Tamper resistant cover, cartridge control kit

Model:
991-038

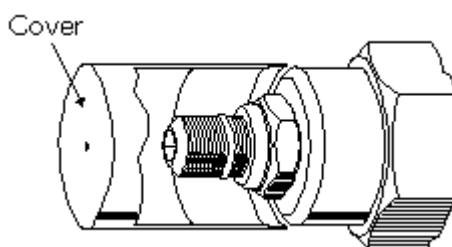
Sun Hydraulics introduces a new style of tamper resistant cap for Series 1 cartridges. The deep drawn metal can (zinc plated steel) has been replaced by a black Delrin®, injection molded cap. This new design is easier to install, more tamper resistant and does not corrode. All of Series 1 products with a 'C' control are currently being shipped with the new style tamper resistant cap.
